Change Notice No.	Notification date	Implementation date
CN/19/001	February 05, 2019	March 05, 2019

Subject : Change in the inlet/outlet connection of sampling bags used in mdi Single Use Systems

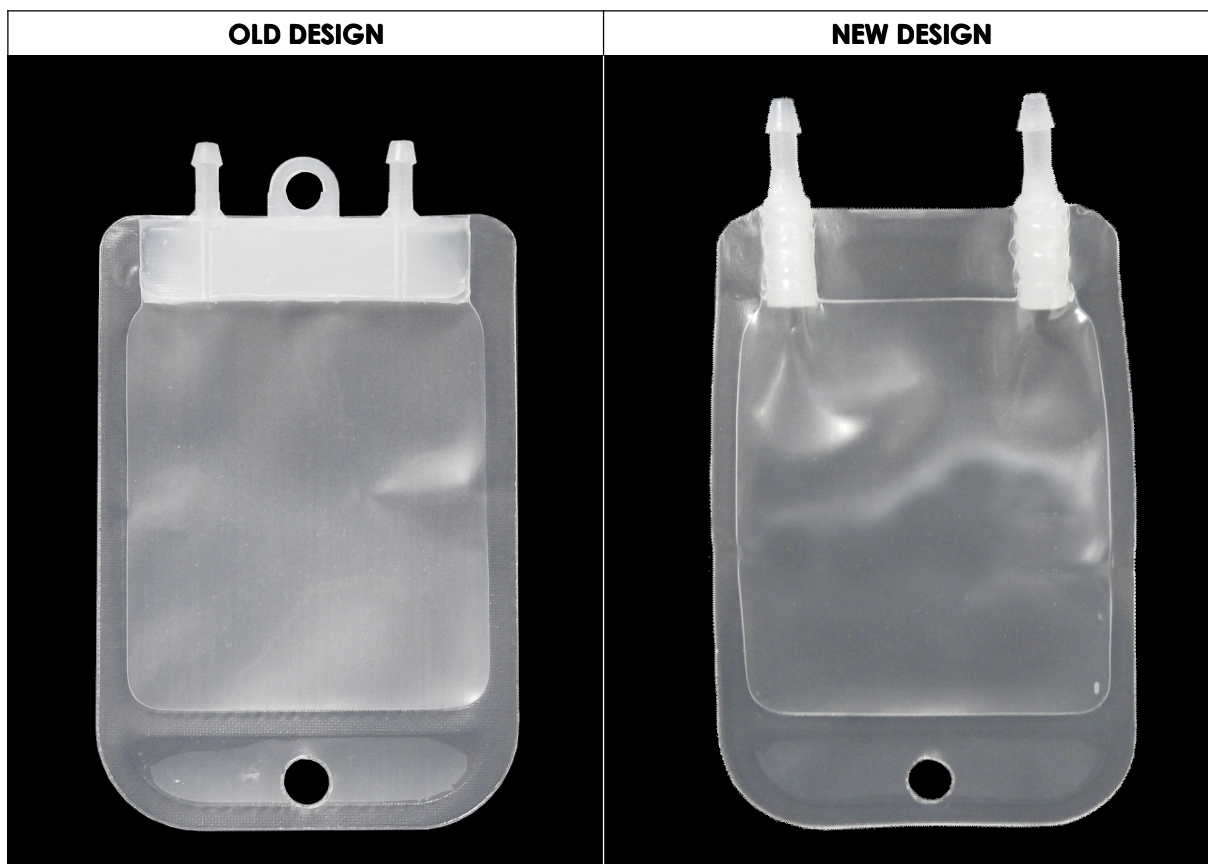
In our efforts to provide the user more robust products, it has been decided to make certain changes in the design of the inlet/outlet connection of sampling bags used in **mdi** Single Use Systems with catalog numbers as mentioned above.

Existing Sampling bags used in the **mdi** Single Use Systems with catalog numbers as mentioned above are manufactured using boat type inlet/outlet connection. These inlet/outlet connections are validated to withstand a pressure upto 5 psi. During usage of the Single Use Systems at customer end, sometimes the pressure generated on these sampling bags is more than the 5 psi. In such cases, a pathway is created next to the inlet/outlet connection of the sampling bag and leakage is observed through this pathway. To overcome this design constraint, it has been decided to introduce a new improved design of inlet/outlet connection in sampling bags. The new design of inlet/outlet connection has been verified for critical product performance parameters including increased operating pressure. No change has been done in any other dimensions or materials of construction.

From a practical point of view this change only improves the operating pressure rating of the sampling bags used in Single Use Systems. All other performance specifications and product attributes remain unchanged, except the increased operating pressure.
